# Town of Hilton Head Island Regular Design Review Board Meeting

### **Project Narrative for the Sunset Pavilion at Skull Creek Boathouse**

## DESIGN TEAM/DRB COMMENT SHEET

## DESIGN TEAM/DRB COMMENT SHEET

**1 SITE PLAN**  
 SCALE: 1/16" = 1'-0"

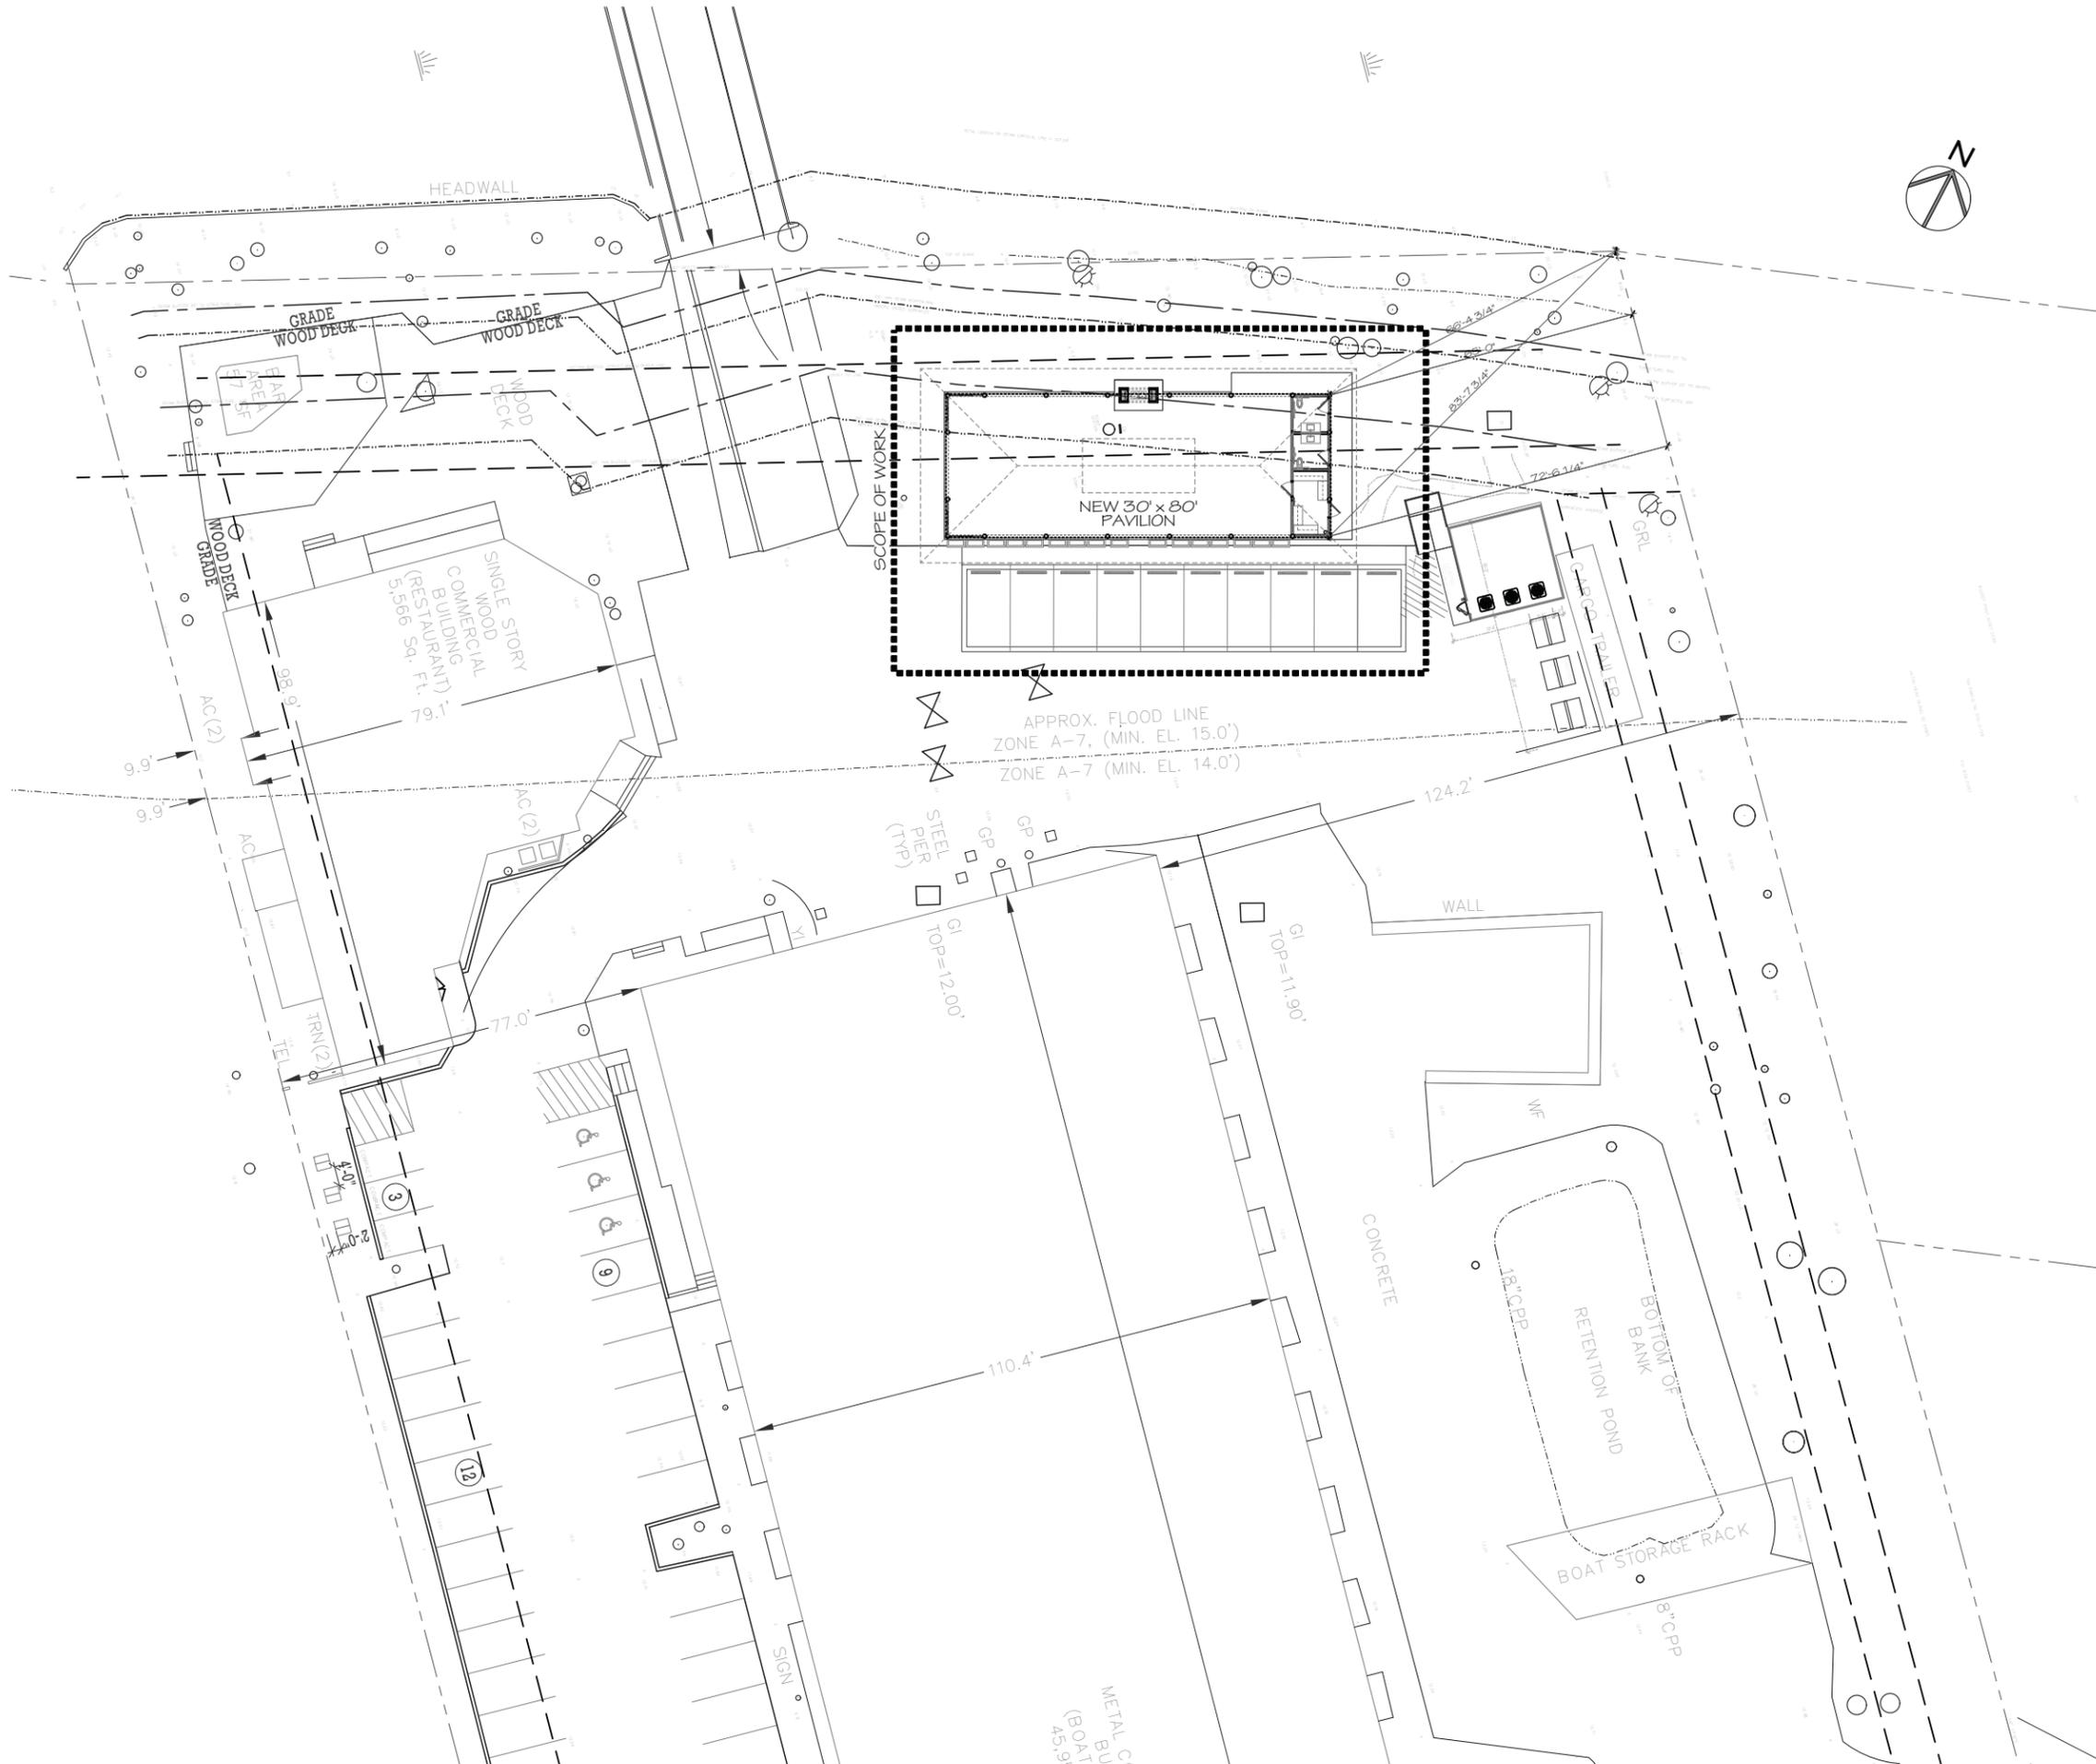
1. Add 40' average wetland buffer to the site plan.
2. Add canopy dripline and height of the lowest branches on the pavilion side to the live oak clusters adjacent to the pavilion.
3. The roofing material shall be a standing seam metal in a bronze color.
4. Reduce the pavilion roof overhang on the parking lot side to accommodate planting.
5. Provide a planting plan to be approved by Staff for the area between the parking lot and the pavilion to screen the parking lot.

<b>DESIGN GUIDE/LMO CRITERIA</b>	<b>Complies Yes</b>	<b>No</b>	<b>Not Applicable</b>	<b>Comments or Conditions</b>
Wetlands if present are avoided and the required buffers are maintained	<input type="checkbox"/>	<input checked="" type="checkbox"/>	<input type="checkbox"/>	Submit a site plan showing that the pavilion and the seating area near the fireplace meet the 40' average wetland buffer per LMO Section 16-6-102. Note that the average buffer is 40' feet from tidal wetlands. The average buffer is measured from the OCRM line to the nearest structure. The seats and tables around the fireplace meet the definition of "structure." In LMO Section 16-10-105, "structure" includes anything portable that requires a location on a parcel of land. Please ensure the measurement of the 40' average wetland buffer includes the chairs and tables around the fireplace and the pavilion.

1. The DRB approved revision to the front parking lot and boat rack storage on this site on Feb. 28, 2017.
2. The 11/26/22 and the 11/27/21 Live Oak clusters are within an inch of being specimen size. Revise the plans to show the canopies of the clusters along with the location and height of the lowest limbs near the pavilion. It appears the tree survey may be out of date. Note the specimen tree protection standards in LMO Section 16-6-104.F.2. Note the no paving or soil compaction is allowed within 15 feet of a specimen tree trunk, and no more than 20 percent of the total area within the drip line of any specimen tree shall be subject to paving or soil compaction. If these are specimen tree clusters, the plans will need to demonstrate that these standards are met.

**1 ROOF PLAN**  
SCALE: 1/4" = 1'-0"

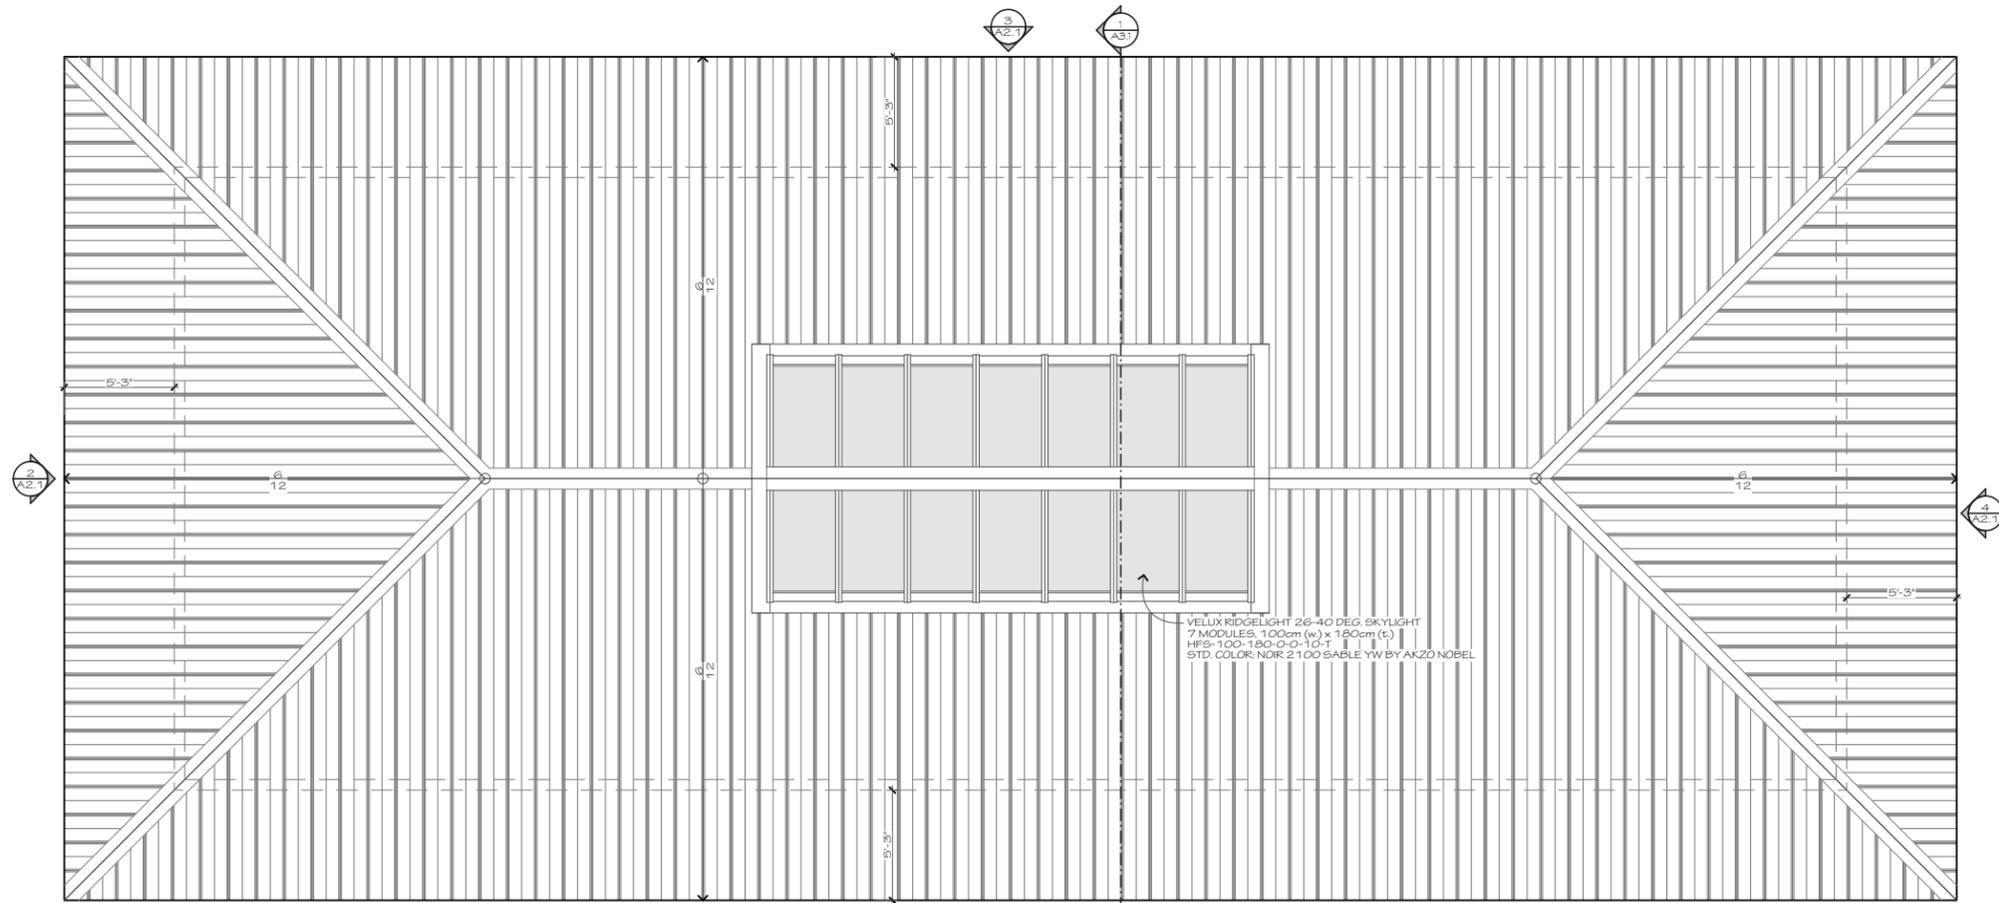
**From:** [Joe DePauw](#)  
**To:** [Darnell Chris](#)  
**Subject:** Skull Creek Boathouse Roof  
**Date:** Friday, March 01, 2019 9:48:06 AM

Thanks for the call yesterday. The roof on the boathouse restaurant is in fact a 1" standing seam. Our intent is to match that roof on the new pavilion, so we'll use standing seam there instead of 5-V. I can give you updated drawings if that would be appropriate.

DRAWING TITLE  
**PLANTING PLAN**

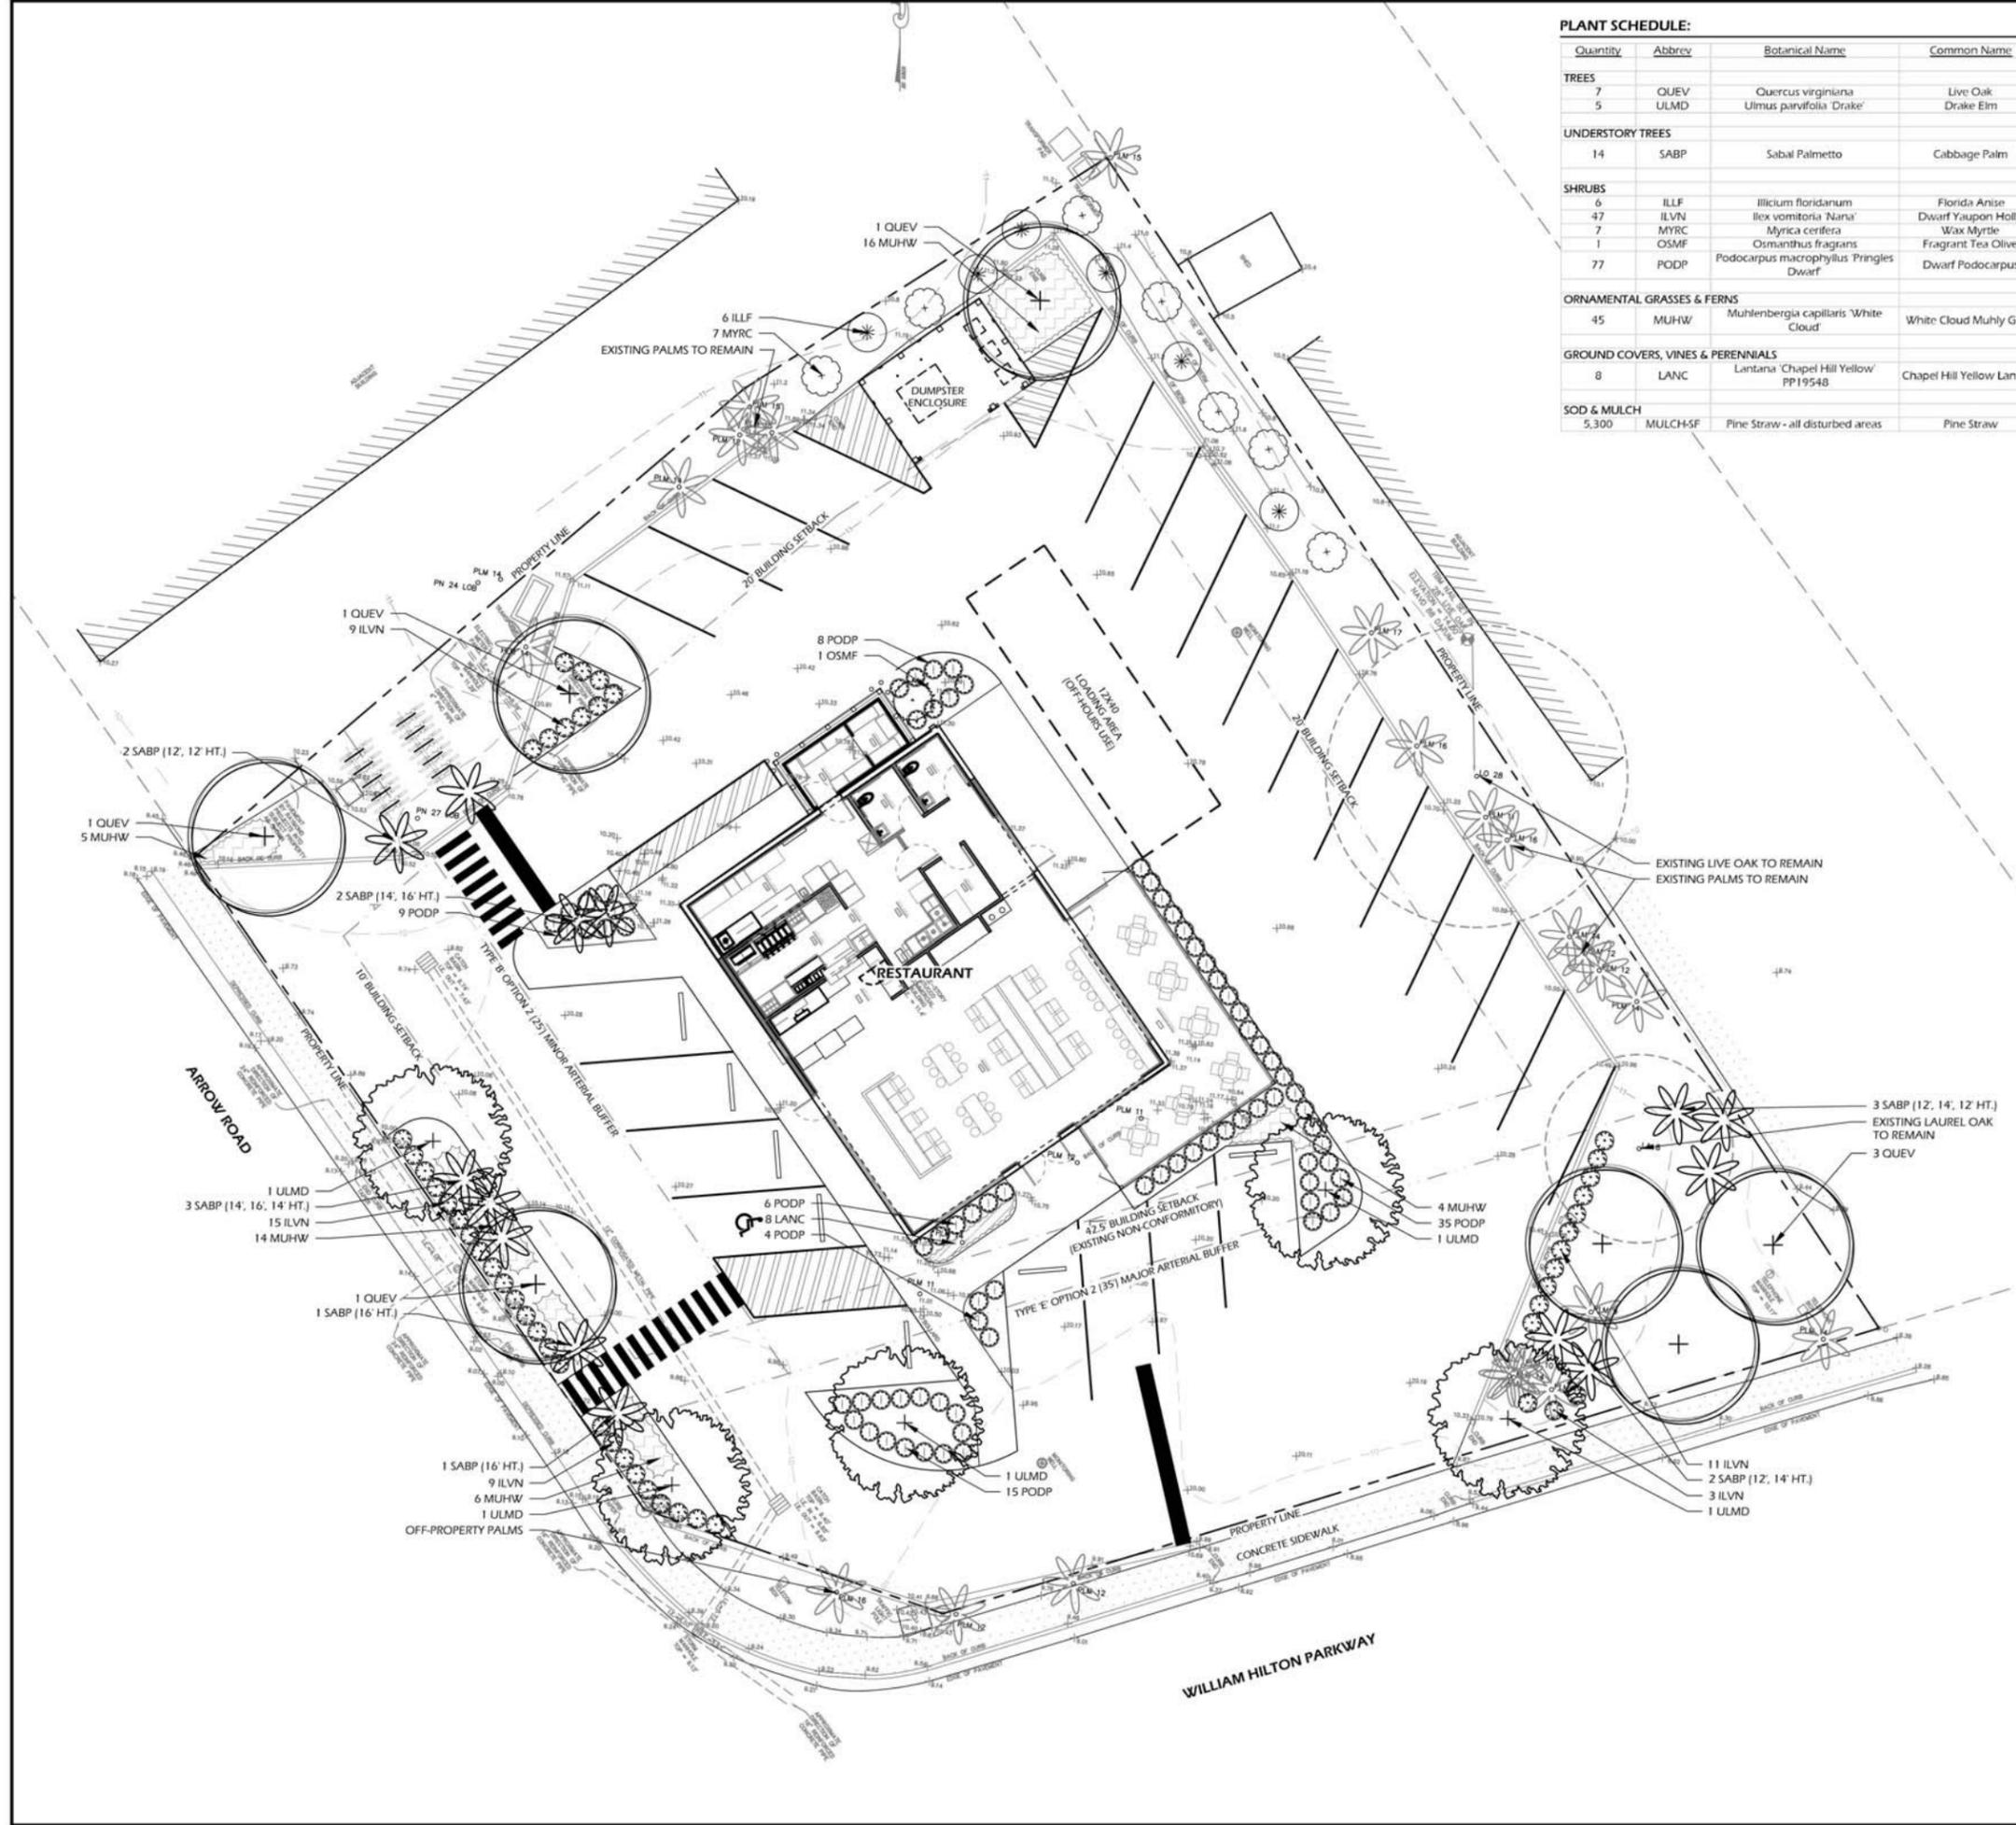
1. Remove the pavement on the southwest side of the dumpster enclosure to make space for additional planting for review and approval by Staff.
